Conceptual Review Agenda

Monday, April 22, 2013

Storybook 2nd Filing
SF Homes

Re: Storybook 2nd Filing
Description of project: This is a request to build 76 single family homes, on 14 acres, in similar layout as the original Storybook 2nd Filing, located northeast of the intersection of Mountain Vista Drive and Turnberry Road. The dwellings would be a mix of single family attached and single family detached units. The 14 acres are considered to be expired with no vested right to develop. Portions of the site already contain improvements (e.g. road, sidewalk). The site is located in the Low Density Mixed-Use Neighborhood (L-M-N) Zone District. Single family detached and attached dwellings are permitted in the L-M-N, subject to Administrative (Type 1) review.

CLIENT: GARY MACKEY
PROJECT: STORYBOOK 2ND FILING
FORT COLLINS, COLORADO
UNIT: Minor Amendment SITE PLAN

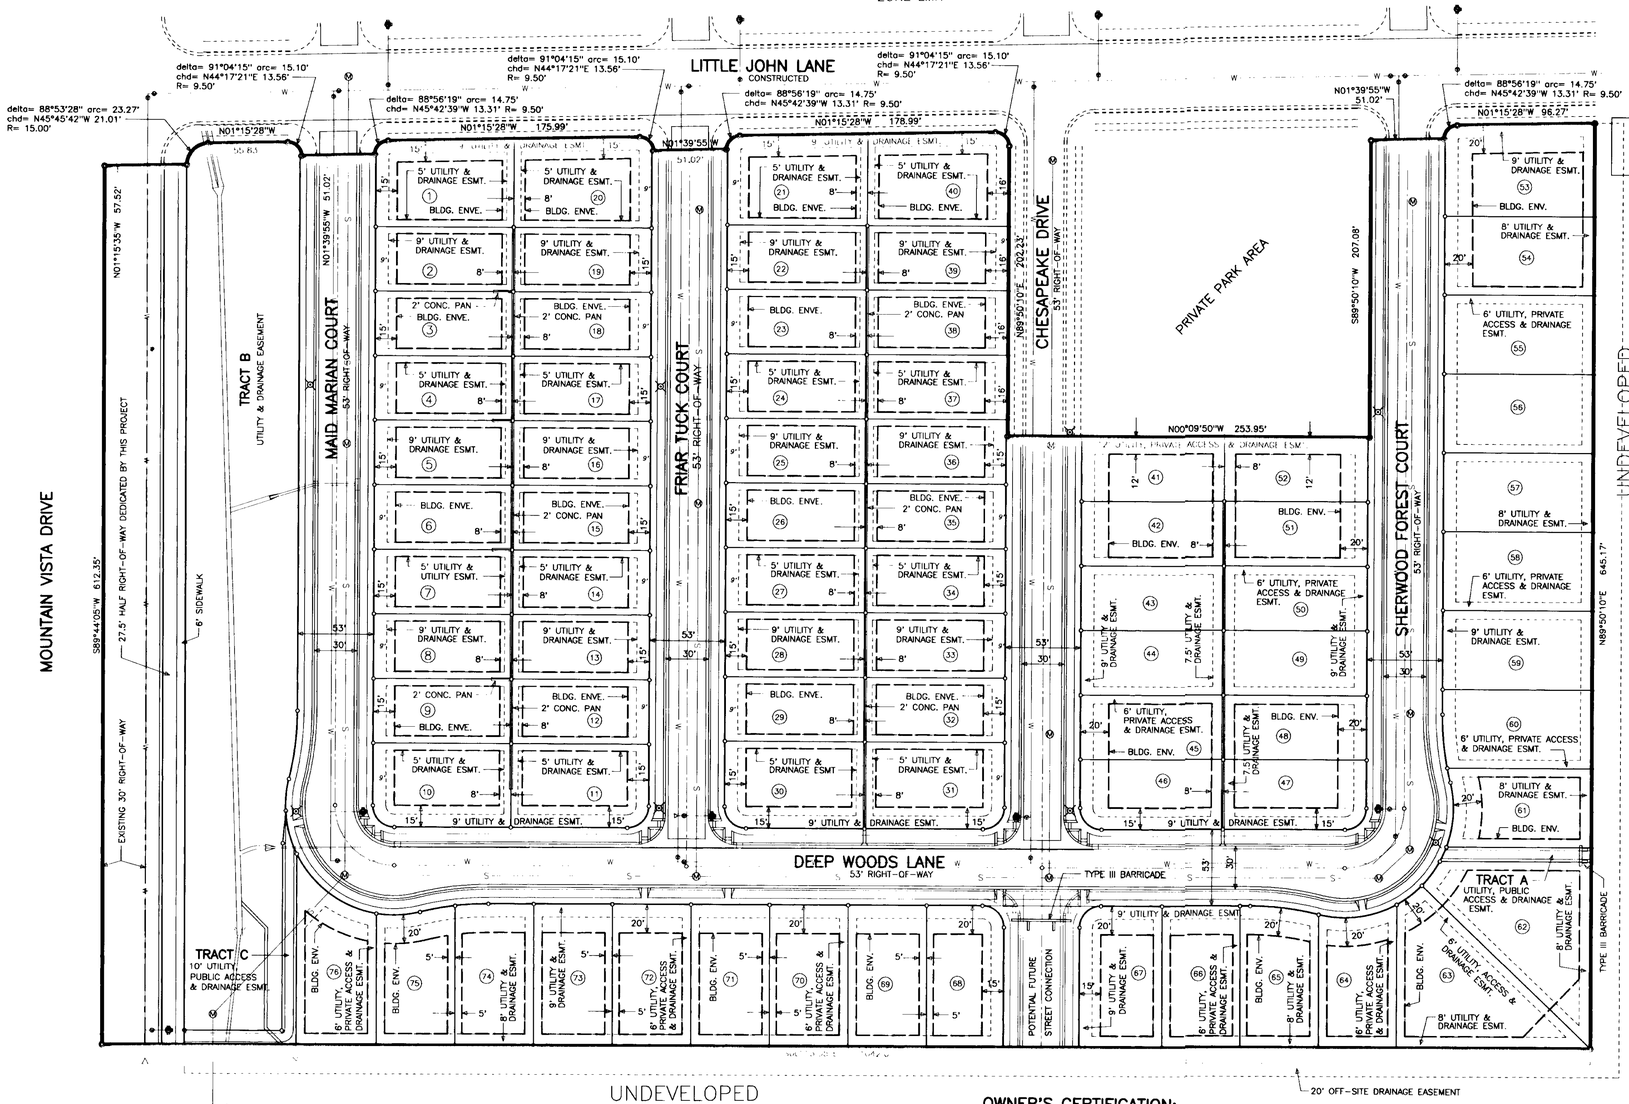
3. The approved, but expired, plans indicate a maximum allowable height of 22 feet. This could be amended as the maximum height in the L-M-N zone is not set by a specific number of feet but rather as 2.5 stories.

4. The approved landscape plan indicates that there will be one street tree per lot and two in the case of corner lots, and in some cases, more trees are provided.. Also, be sure to continue the landscaping along the south side of Maid Marian along the swale east of Little John to match the treatment on the west side of Little John. Landscaping will be required in no less quality than the approved plan, particularly in highly visible areas such as along Mountain Vista Drive.
